UNITED STATES  
NUCLEAR REGULATORY COMMISSION  
WASHINGTON, D. C. 20555

Docket No. 50-508

SUBJECT: SUMMARY OF MEETING OF THE STAFF WITH  
WASHINGTON PUBLIC POWER SUPPLY SYSTEM  
CONCERNING GEOSCIENCE ISSUES FOR WNP-3  
(WPPSS LETTER DATED 11/20/87), APRIL 5,  
1988

Figure 2.5-31

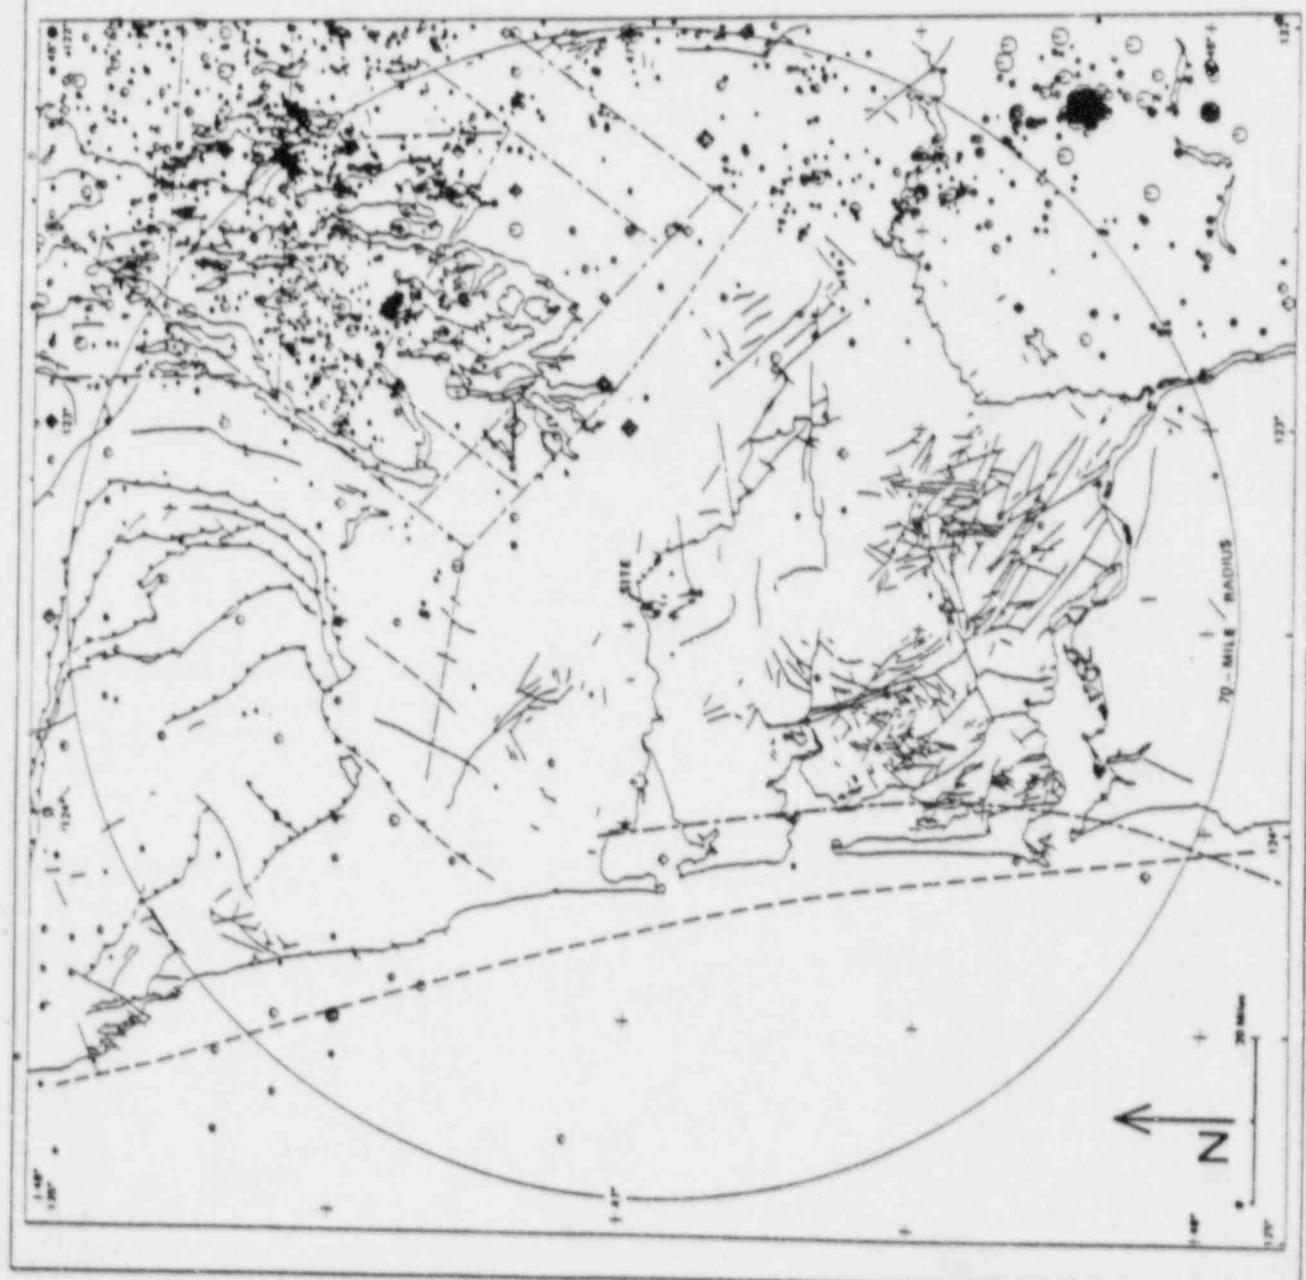
Attention is called to FSAR Figure 2.5-31. No location errors are specified for most of the earthquakes plotted thereon, especially for those occurring in a region which projects to the southwest of Olympia on section AA' and particularly for depth of focus.

Expand your explanation of the decrease in seismicity on the sections through the site west of point B in Figure 2.5-31.

## Important to Update Figure 2.5-31

- 1970-1980 catalog has been re-evaluated by U of W staff
- Additional data from 1981-1986
- Greater detail on geometry of subducting Juan de Fuca plate
  - Cresson and Owens (1987)
  - Baker and Langston (1987)
  - Baker and Wenner (1988)

Figure 230.3e-1

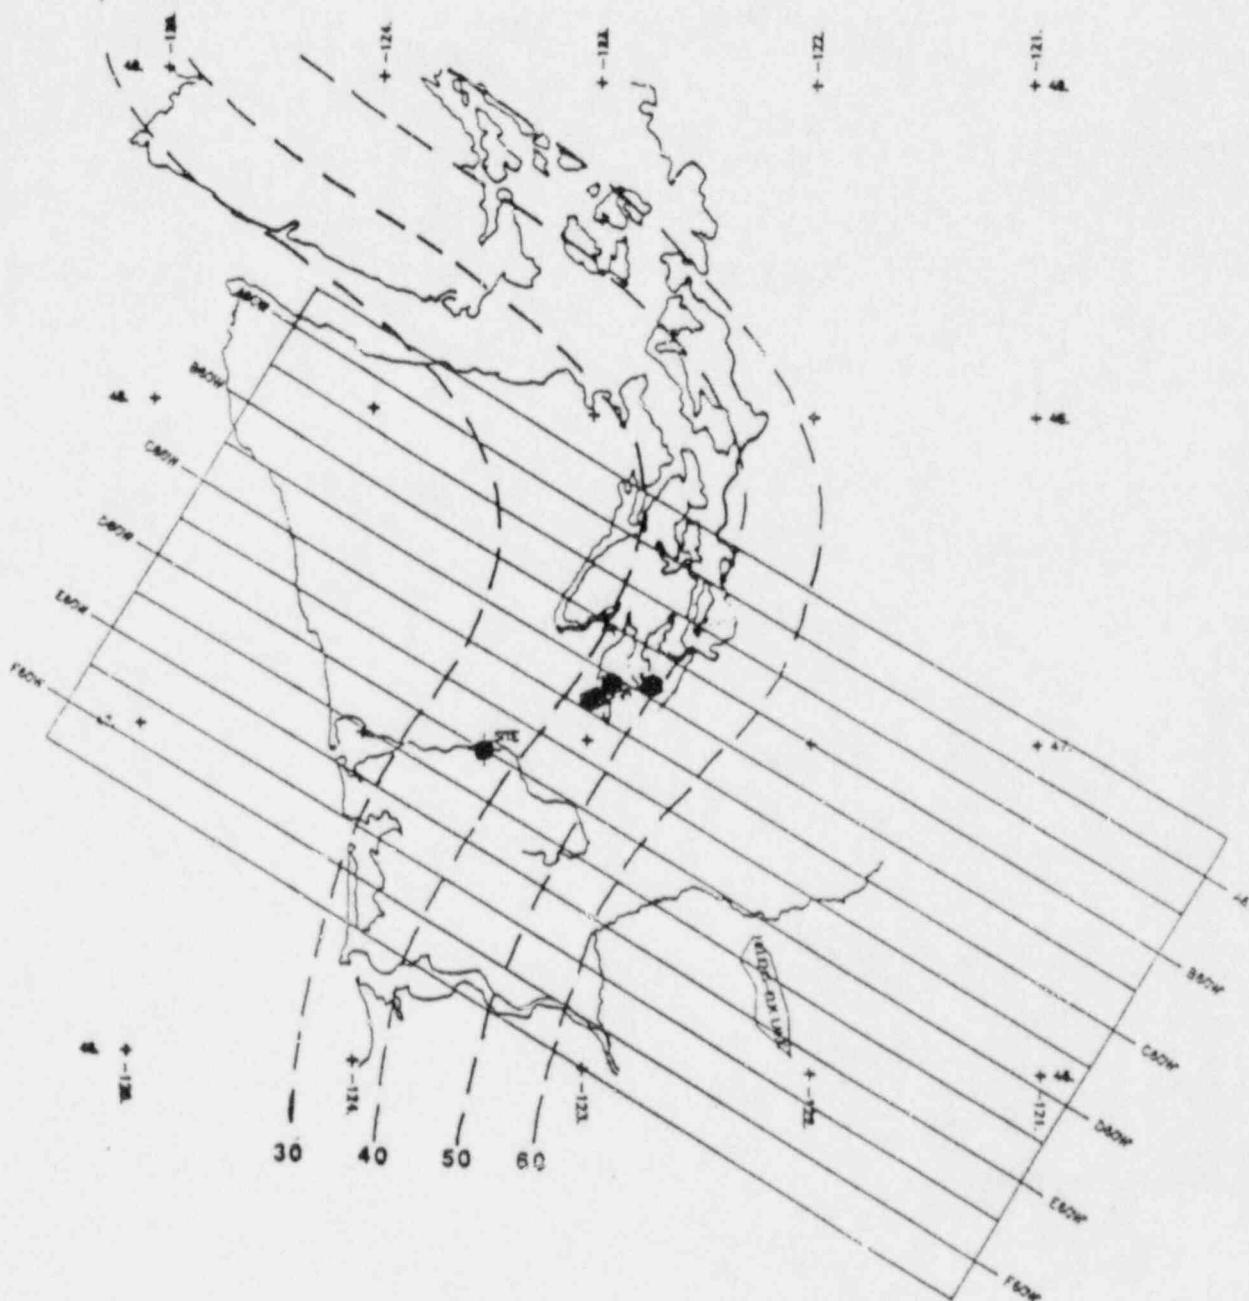
The Puget Sound earthquake of February 15, 1946, is a large earthquake with uncertain depth (Rasmussen, Millard, and Smith, 1974). If this event was relocated at a shallower depth or farther to the west, it may significantly alter the applicant's conclusions about the earthquake potential of the subduction interface or the overriding plate. The International Seismological Summary for 1946 (1954) lists over 40 observations for this earthquake. The observations range in distance from as close as Seattle to as far as Lome in the Ivory Coast. Despite the existence of these data, the applicant chose not to do a computer relocation (FSAR p. 2.5-120). We request that the applicant relocate this earthquake using the published I.S.C. data and establish the relationship of this earthquake to the Juan de Fuca-North American plate interface.

used Program TELES (B. Bolt)  
Jeffreys-Bullen earth model  
ISS data (42 stations)

## 4 Analysis Cases

- 1) data with residuals  $\leq$  30 sec (36 stations)
- 2) data with residuals  $\leq$  15 sec (34 stations)
- 3) data with residuals  $\leq$  10 sec + Washington state data (34 stations)
- 4) only data with residuals  $\leq$  10 sec (32 stations)

In addition depth determined using  
 $P-P$  times & VofW velocity model

Figure 230.4b-i Published Locations for 1904 Earthquake

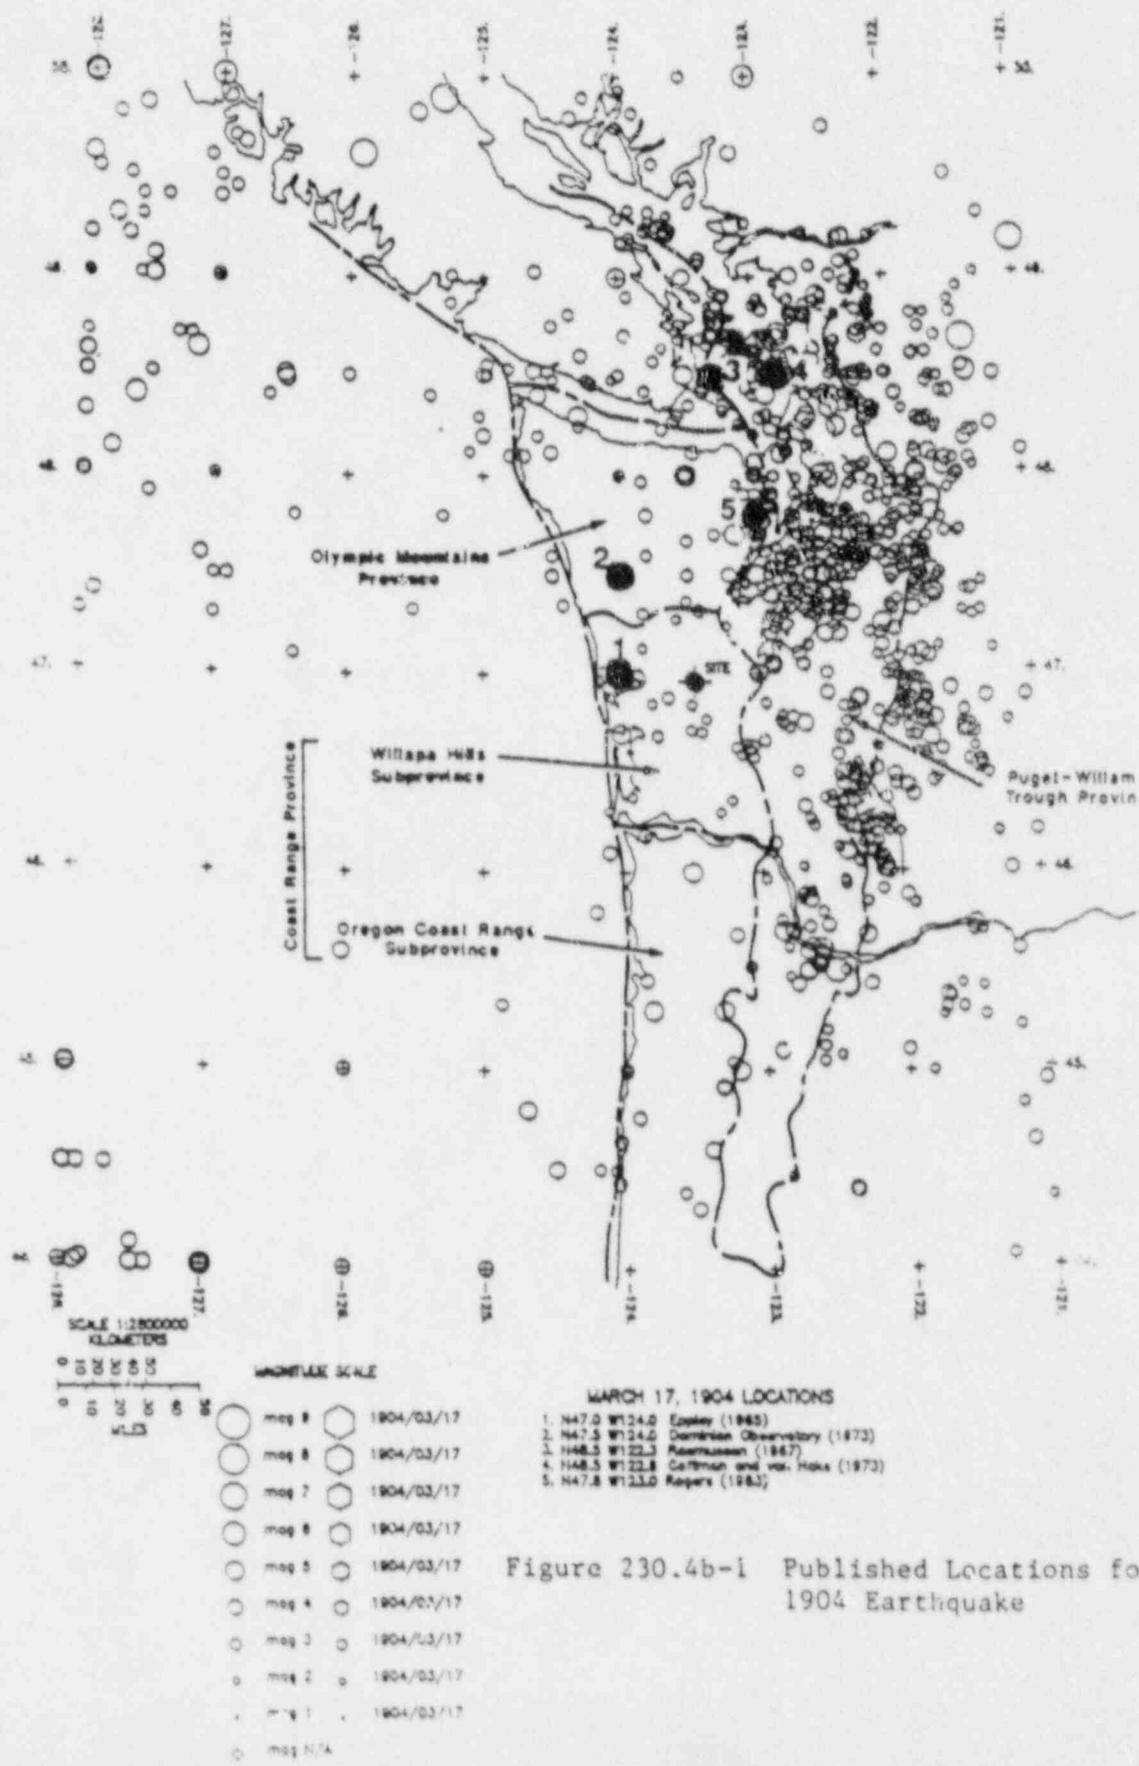
Inasmuch as the 17 March 1904 earthquake has not been associated with a structure at any of its various hypothetical locations (pp. 2.5-127, 128, FSAR), show why the size of this earthquake should not be considered the size of the "random earthquake".

- Early locations rounded off to nearest  $1^\circ$  or  $1/2^\circ$
- Location developed by Rogers (1983) consistent with isoseismals presented in FSAR Fig 2.5-70  
These are based on felt reports in Townley & Allen & local newspapers
- Rogers' location & isoseismals suggest event located on western edge of Puget Sound seismic zone
- Rogers' estimate of  $M_L$  5.3 based on Toporowski (1975)  
$$M_L = -1.83 + 1.53 \log_{10} (\text{felt area})$$
& felt area of  $20,000 \text{ km}^2$  reported by Rosanessen (1967)  
Felt area shown in Fig 2.5-70 ( $40,000 \text{ mi}^2$ ) yields  $M_L$  5.7

Figure 230.4b-2 Isoseismal Map for 1904 Earthquake

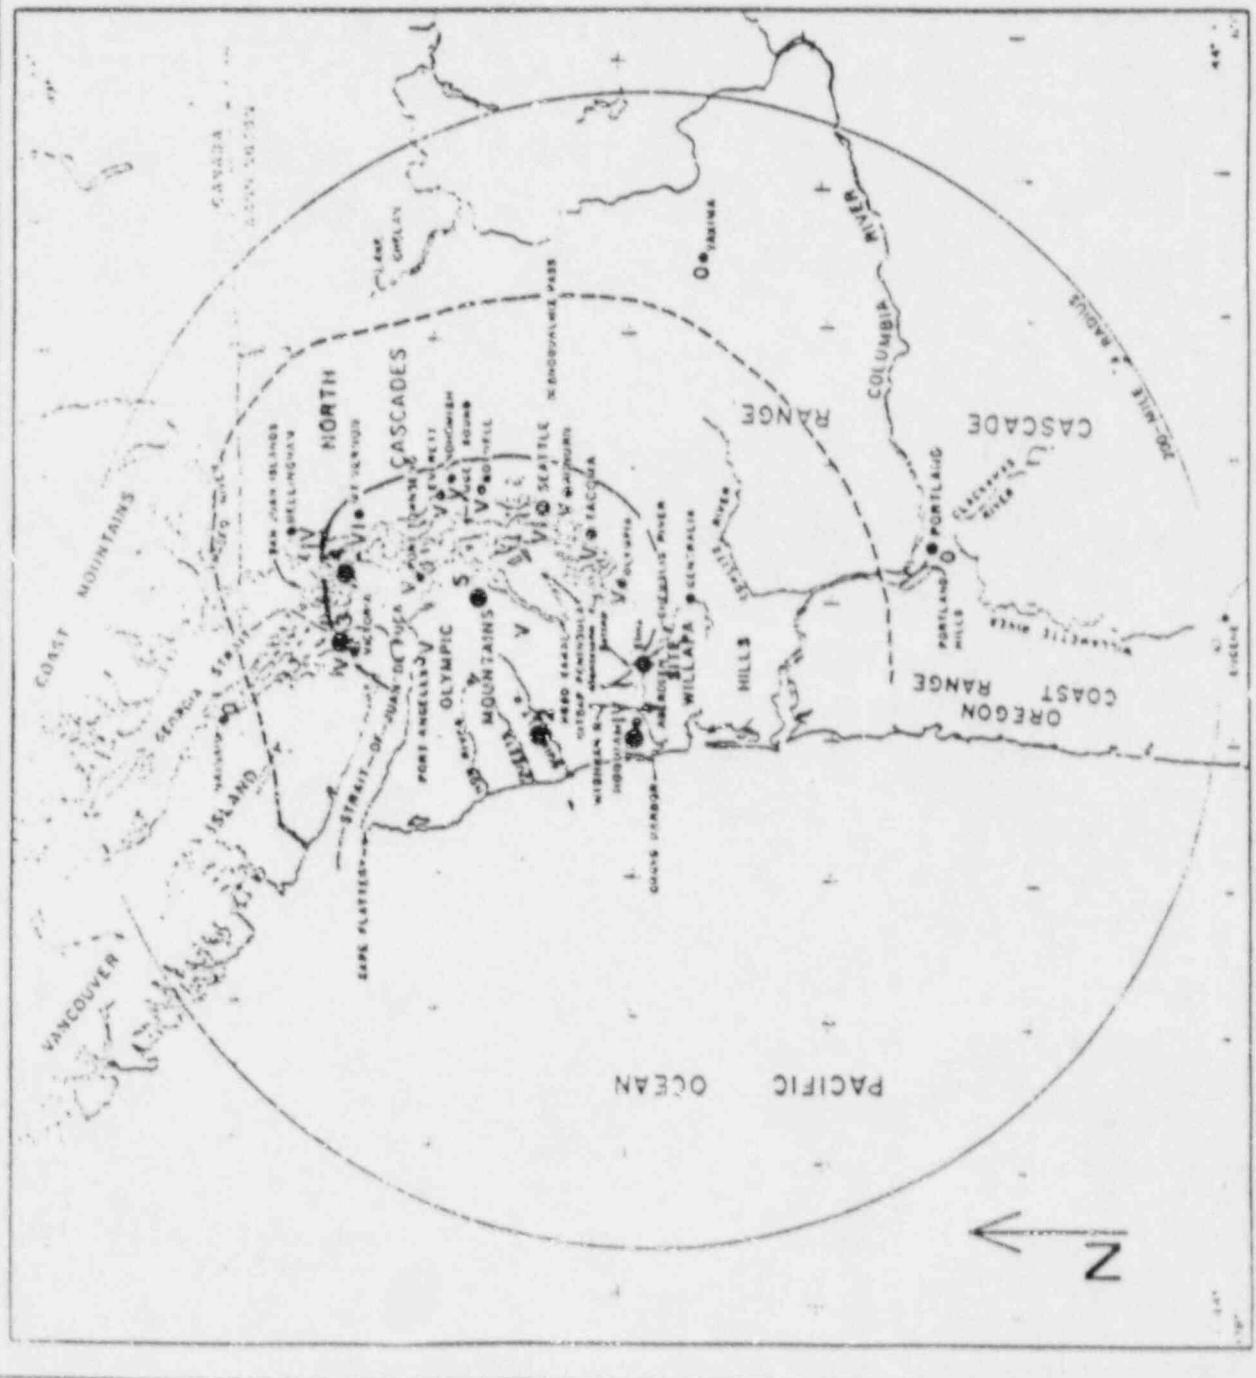
With respect to the 17 March 1904 earthquake, provide all references not in the public sector for the intensities shown in Figure 2.6-90, as well as for any other locations for which information is available which could be used to assess intensity. Provide the documentation for the relocation of the earthquake to "south of Port Townsend" and the assignment of a smaller size (both attributed to the Pacific Science Center, Victoria, B.C., as "Milne, 1981, private communication" and "Rogers, 1981, private communication").

Figure 230.4d-1 Largest Historical Earthquakes in Site Province

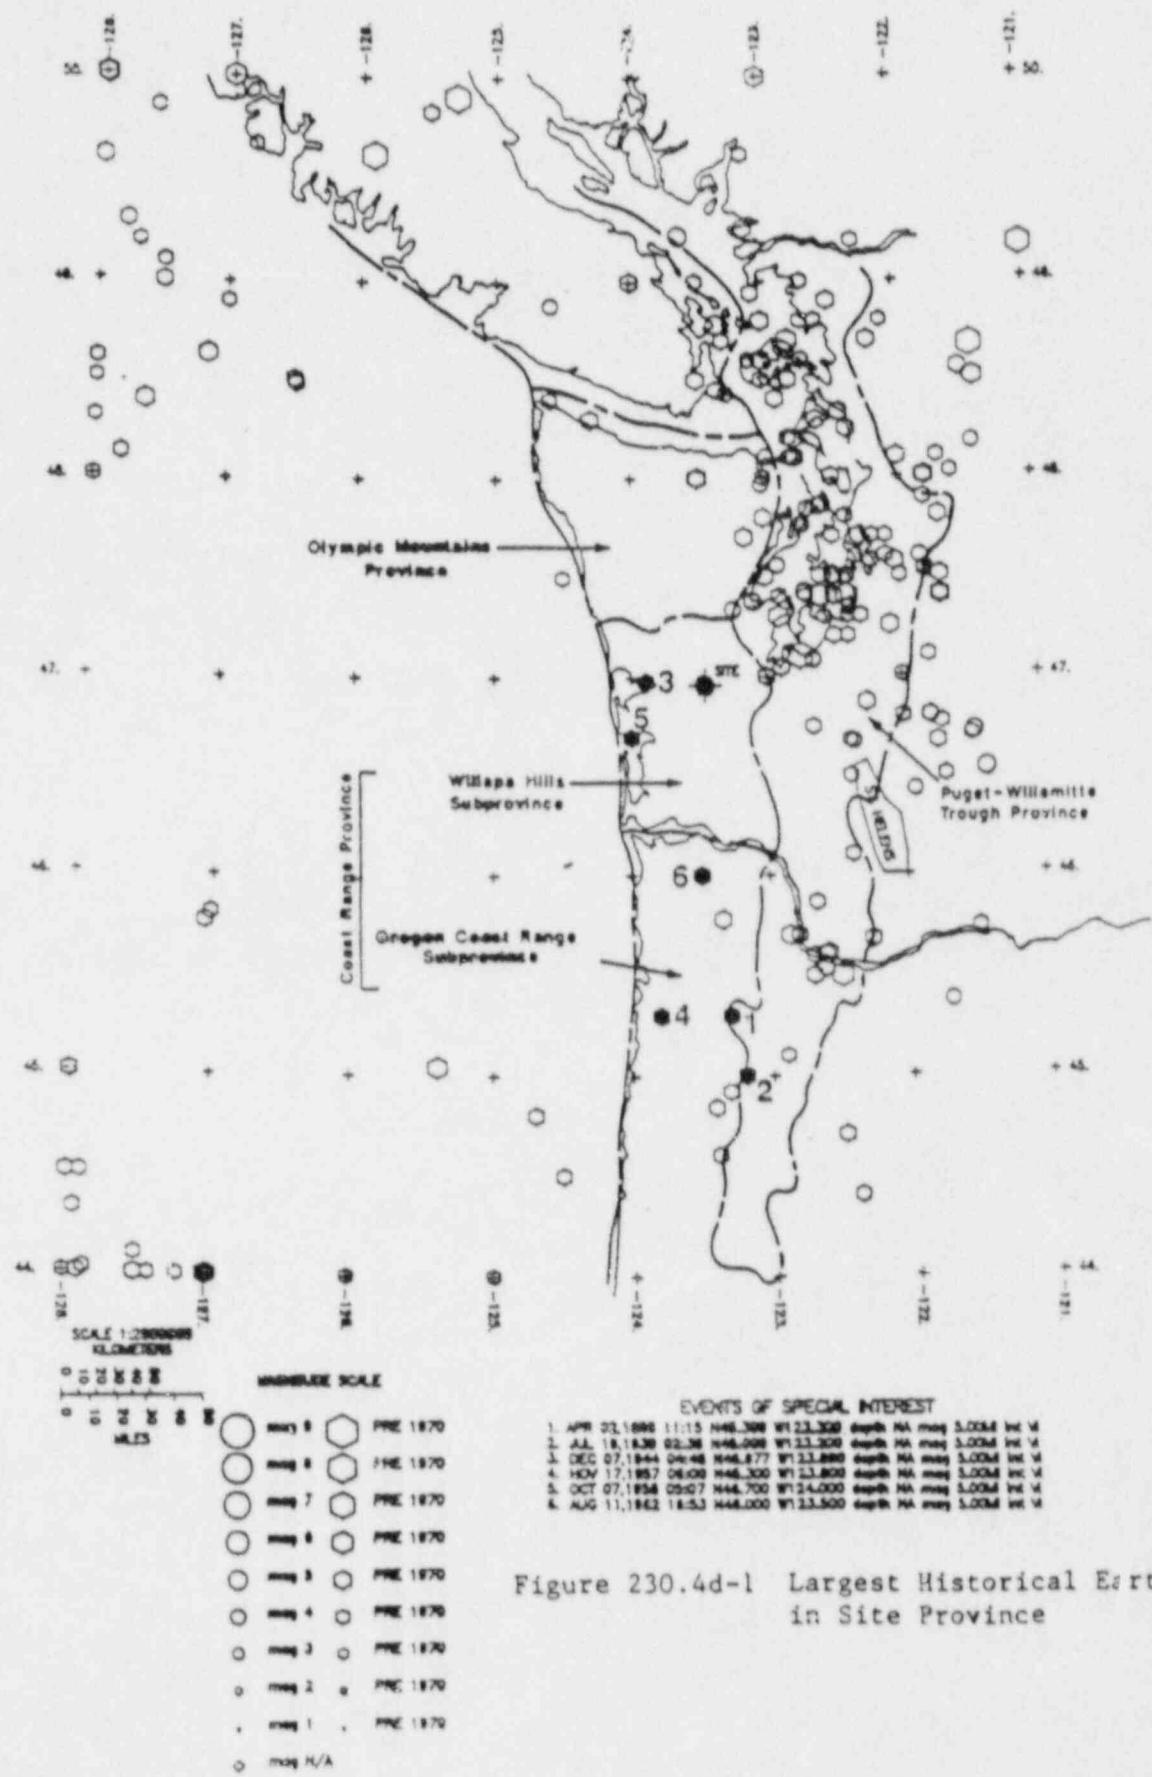
Identify the maximum historical earthquake, not associated with known geologic structure, in the tectonic province of the site. Following Appendix A to 10CFR100, assume this earthquake can occur in the vicinity of the site, estimate the resulting ground motion, and assess the adequacy of the SSE spectrum for this occurrence.
